From: Volex Inc

Re: Engineering Change Notice (Customer Alert)

ECN No. : 004-23A

Sample applied for IEC Cable with BBG/Y insulation:

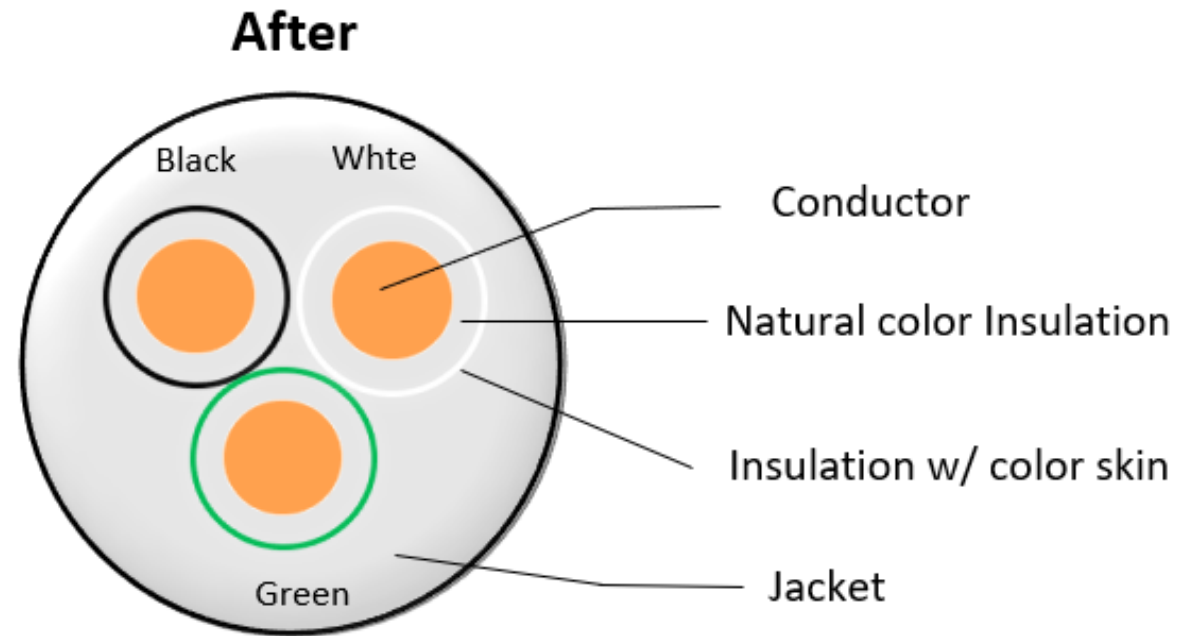
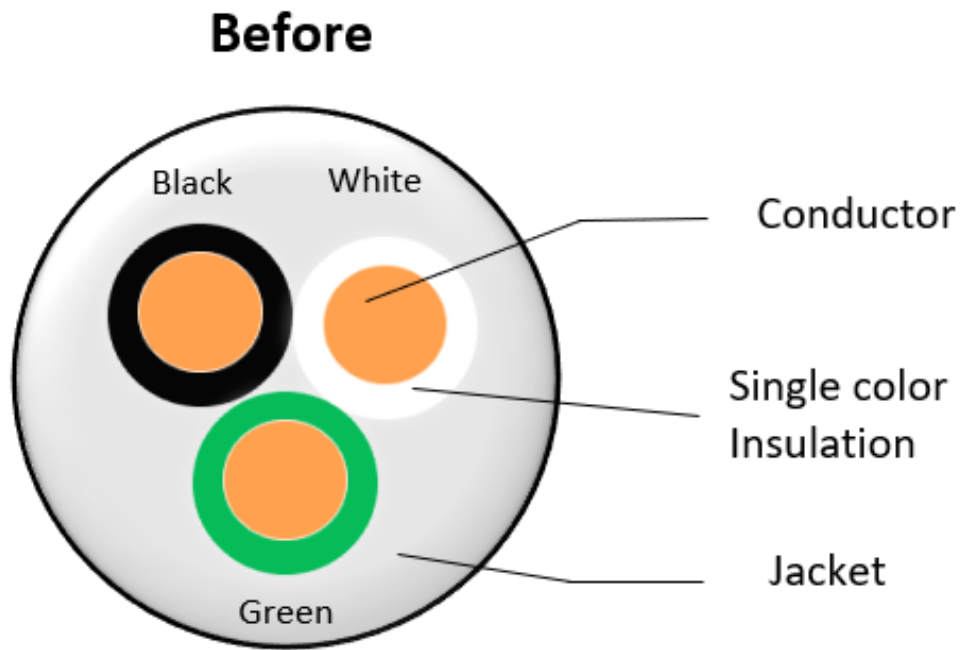
Item	Before	After (skin color insulation)
Insulation for Blue wire	Blue single insulation color	Natural color insulation w/ blue outer skin
Insulation for Brown wire	Brown single insulation color	Natural color insulation w/ brown outer skin
Earth wire Y/G	Yellow with Green striped insulation	Yellow with Green striped insulation
Outer jacket	Single insulation	Single insulation
